Install Add on Harness to filter out the transient voltage spike from wipers to protect the blind spot sytem for resetting

2017 Anthem Class A Motorhomes

2017 Cornerstone Class A Motorhomes

Parts Kit 16-037JM

FIG 1

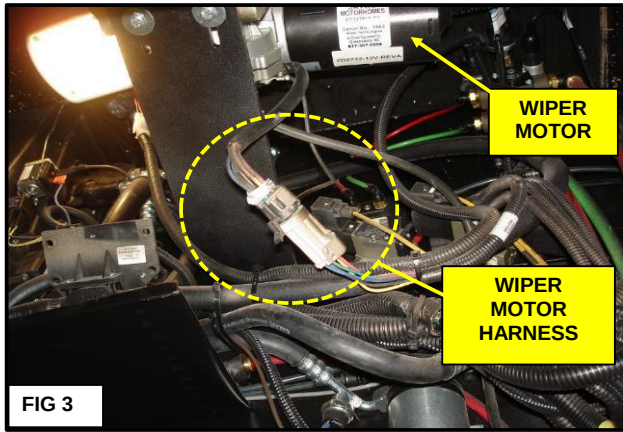
- 1 **Fig 1:** Open the driver side fuse panel compartment and press the generator slide button opening the generator slide (arrow)
Fig 2: Inspect up inside the generator compartment for the Wiper Filter Adapter Harness (arrow)
- 2 If adapter is missing see below.

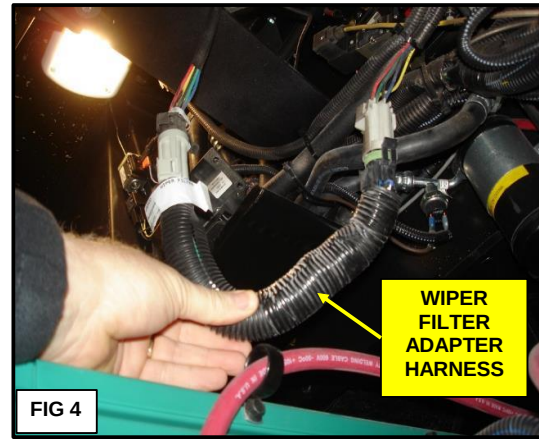
3 **Fig 3:** Locate the wiper motor harness up inside the generator compartment.

Fig 4: Disconnect the wiper motor connectors (shown in Fig 3) and install the adapter between the wiper harness connectors.
